NE WRF IMPROVEMENTS PROJECT PROJECT #19-0029-UT

CITY OF CLEARWATER

ADDENDUM NO. 7

Date Issued: August 11, 2020

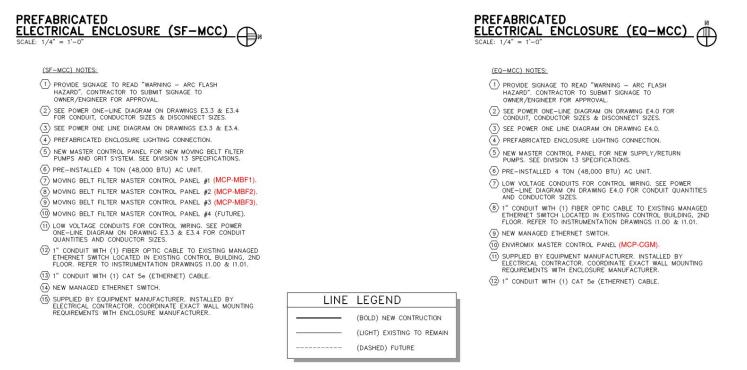
17. On Sheet E2.2, **ADD** the following note at coordinate A5:

"Furnish and install new control panel for (2) new 230-V single phase 1.5 HP sump pumps including new control panel, conduit and wire. The new pump control panel shall be fed from Panel R4 with new 3 No.12 and 1 No.12 E.G. in 3/4" conduit."

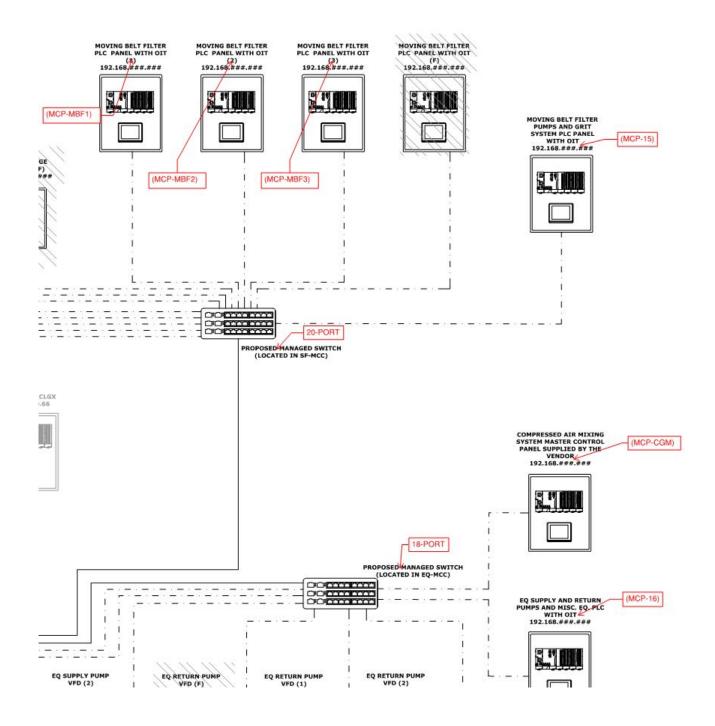
- 19. On sheet E2.3, **CHANGE** Drawing Note 8 to read as follows:
 - "8 New shaft speed sensor (zero-speed switch), typical for two classifiers, one existing and one new."
- 20. On sheet E2.3, **CHANGE** Drawing Note 11 to read as follows:
 - "11 New emergency stop pushbutton for Classifier #2, typical for two classifiers, one existing and one new."
- 21. On sheet E2.4, **CHANGE** General Note 1 to read as follows:
 - "1. All electrical equipment, disconnect switches, conduit, junction boxes, and control panels shall be in accordance with the area classifications defined on Sheet G1.01".
- 22. On Sheet E3.2, **ADD** the following notes shown in red:
